Neshaminy School District
PURCHASING DEPARTMENT
2001 Old Lincoln Highway
Langhorne, PA 19047

Addendum No. 1 dated May 3, 2018
For
Bid #19-20
Purchase of 12 Buses

SEATING CAPACITY: 68 + DRIVER

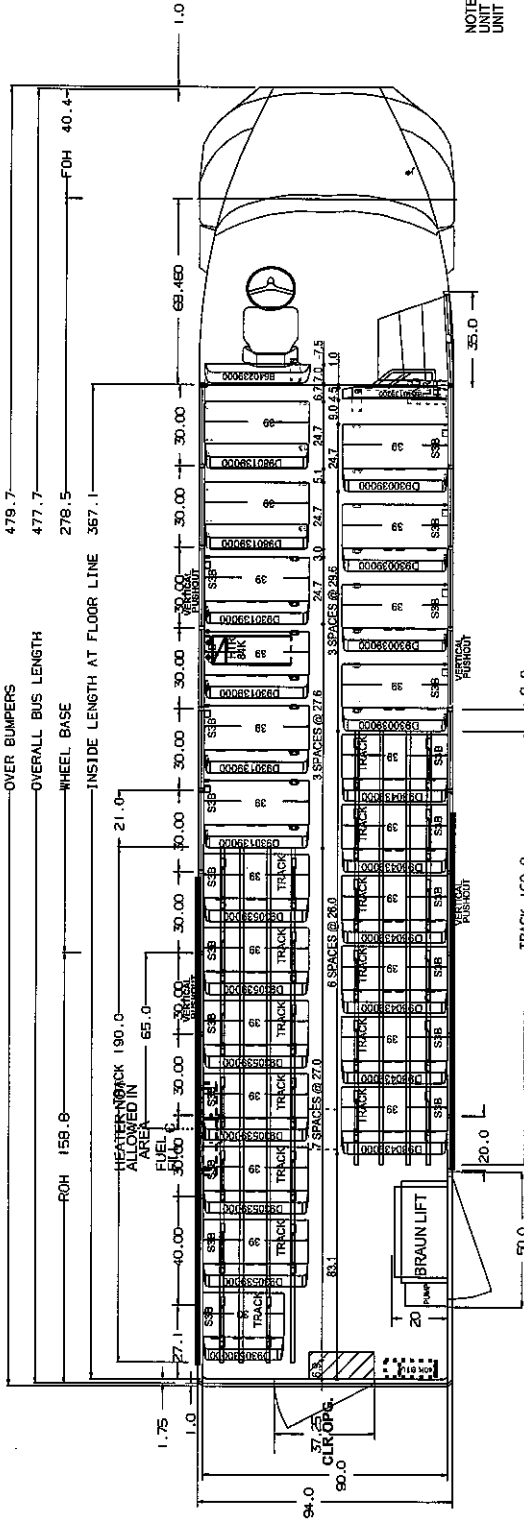
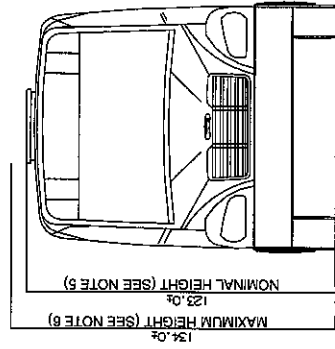
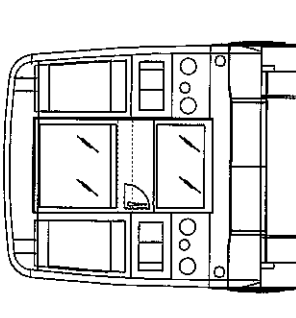
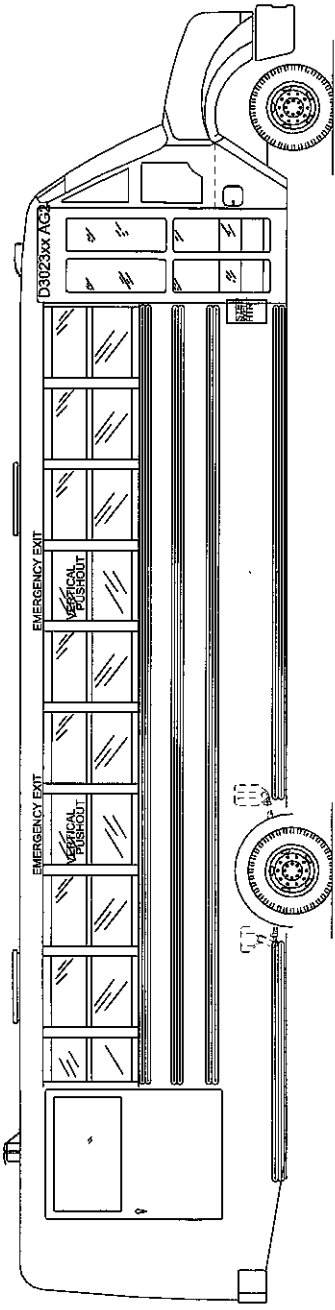
2. For the 78-passenger bus with lift, we are looking for enough room to fit three wheelchairs. Please see the schematic attached for tracking locations.

- a. The wheelbase for this vehicle should be 279”
3. In regards to the Air Conditioning system for the 78 passenger with lift, there are various models but those models only work with certain bus models.
